RE-EVALUATION FORM

A. Re-evaluation Type(s): Design Change

Project Name: US98/SR35/SR700 FROM CR54 TO US301/US98/SR35/SR700

Project Limits: US 98 / SR 35/ SR 700 from Polk County Line / CR 54 to US 301 / US 98 / SR 35 / SR 700 (from MP 0.000 to MP 8.183)

Figure 2

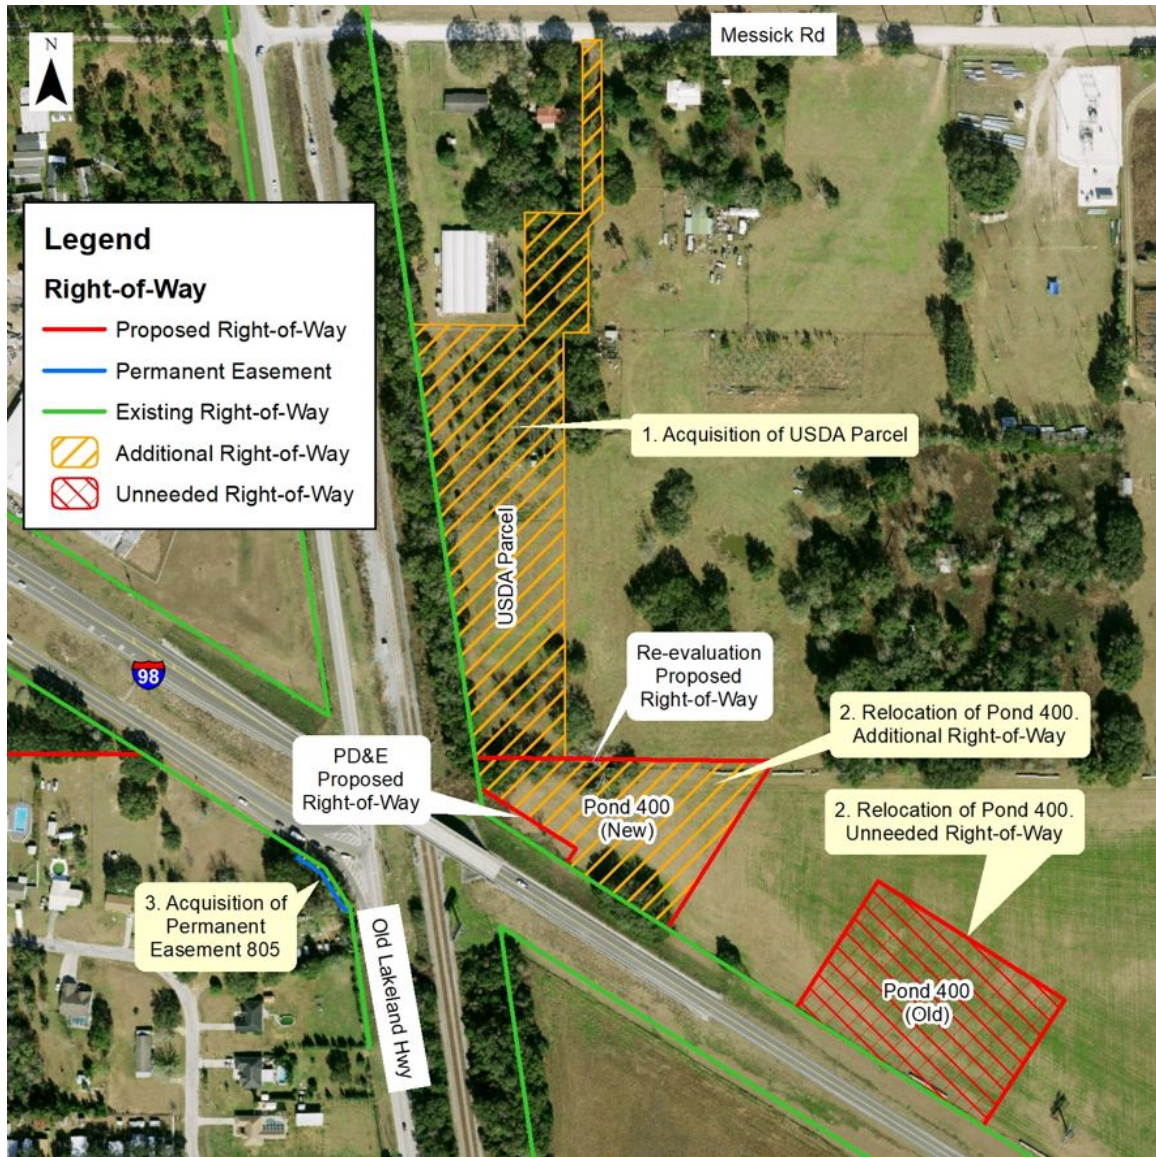
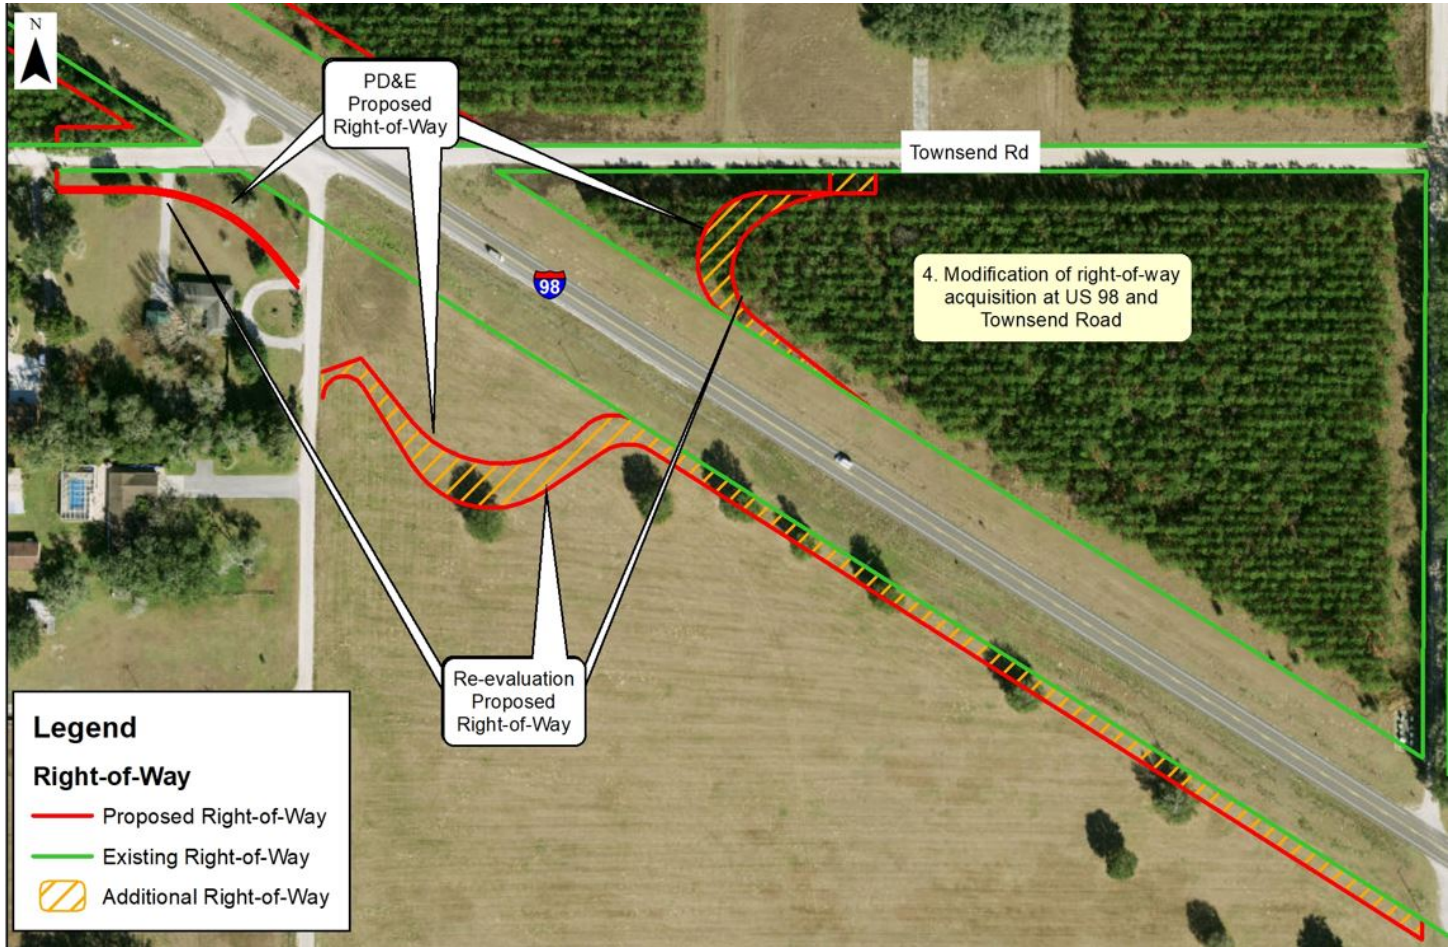
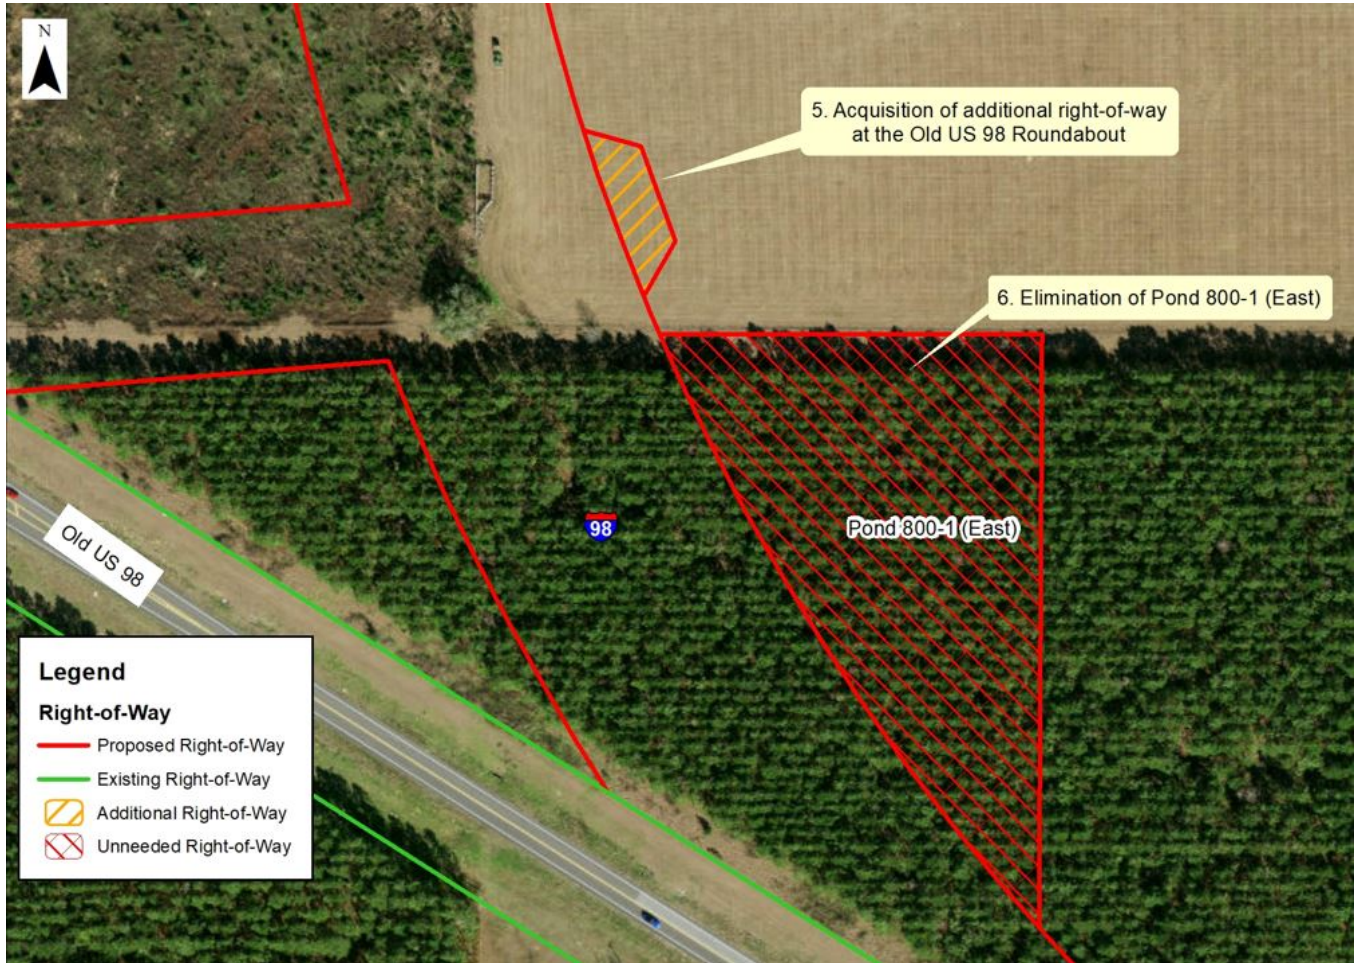
1. Acquisition of U.S. Department of Agriculture (USDA) Parcel for access to Pond 400 (See Figure 2)
2. Relocation of Pond 400 (See Figure 2)
3. Acquisition of Permanent Easement 805 (See Figure 2)

**RE-EVALUATION
FORM****Figure 3**

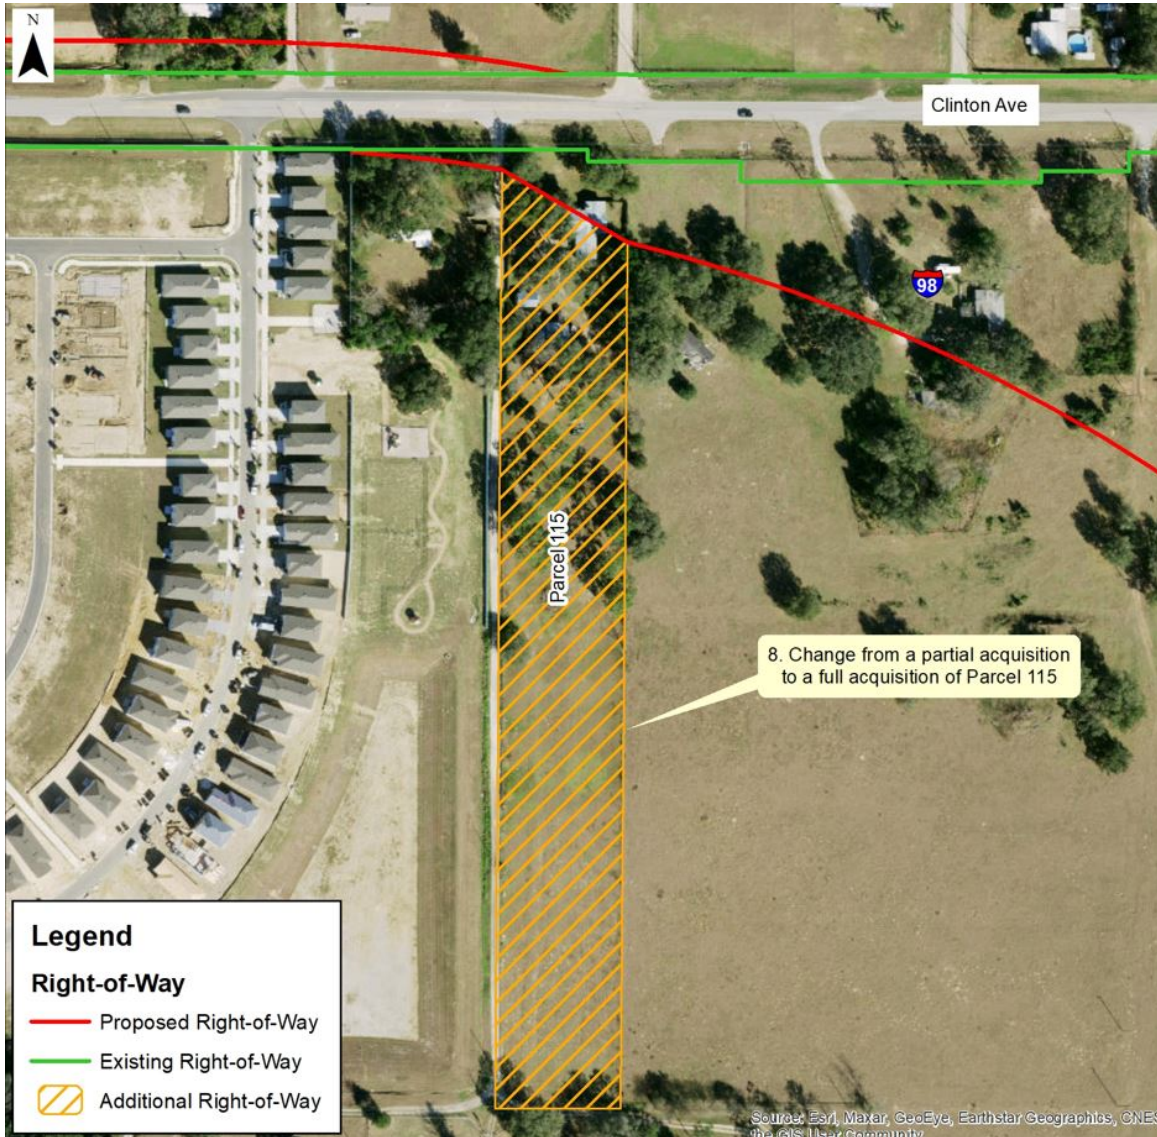
4. Modification of right-of-way acquisition at US 98 and Townsend Road (See Figure 3)

Figure 6

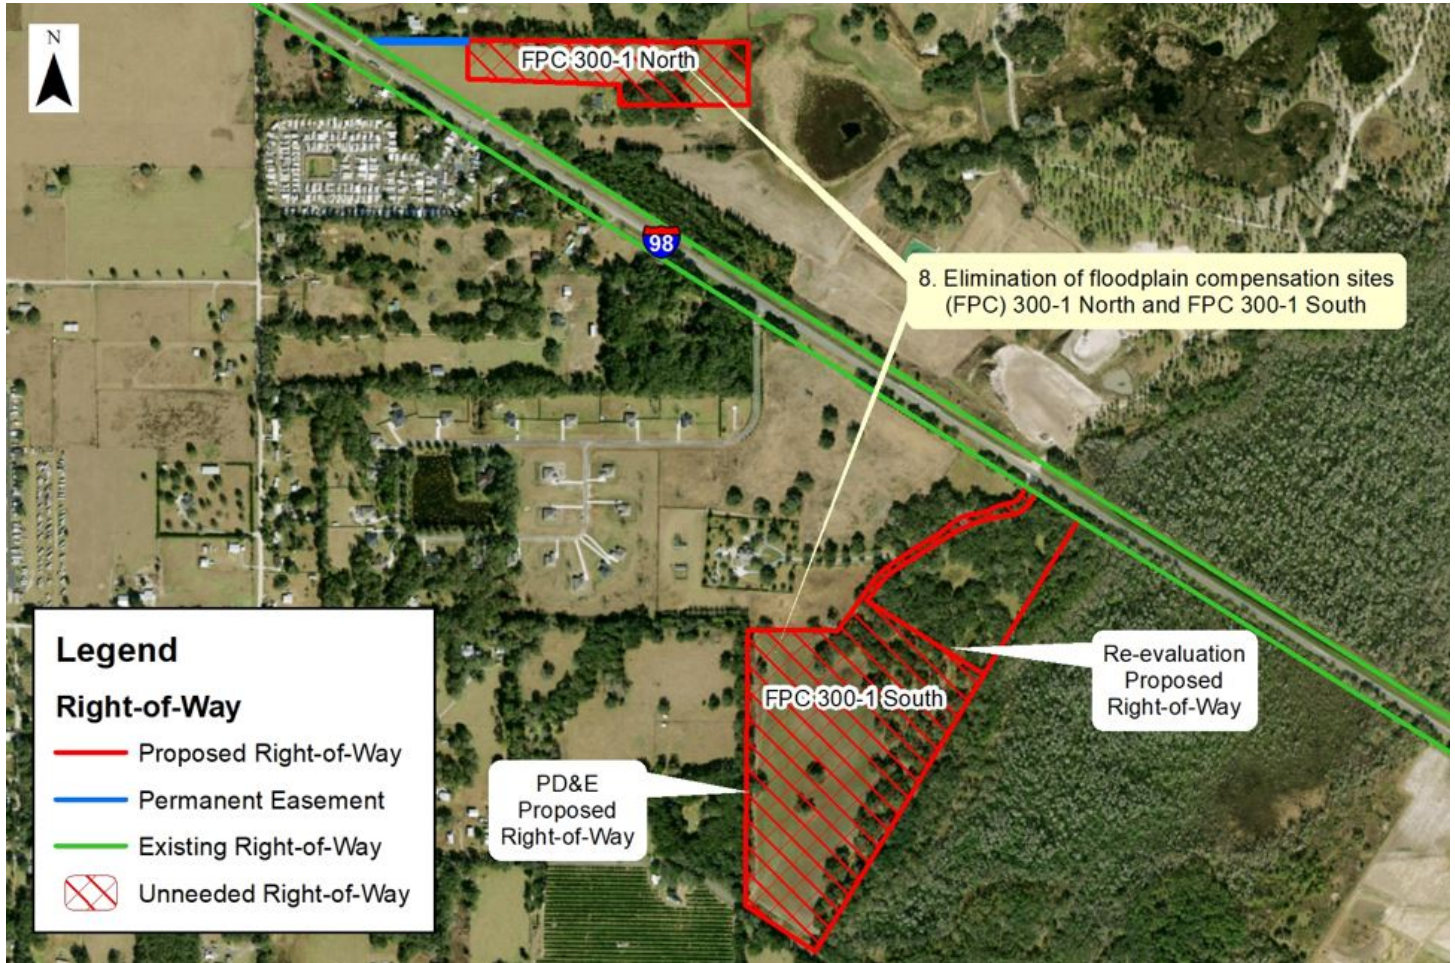
8. Elimination of floodplain compensation sites (FPC) 300-1 North and FPC 300-1 South (See Figure 6)

The mitigation for floodplain impacts was modified during the permitting of the project. Floodplain compensation sites, FPC 300-1 South and FPC 300-1 North, were removed as part of the Environmental Look-Around that discovered available surplus floodplain compensation at the Boarshead Ranch Mitigation Bank. This surplus compensation was memorialized by Boarshead Ranch under permit number 43040444.001 with the Southwest Florida Water Management District. This permit has since been modified under 43040444.081, to authorize the transfer of 146.38 acre-feet of surplus compensation to FDOT to provide floodplain compensation for the widening of US 98, in lieu of the FPC sites.
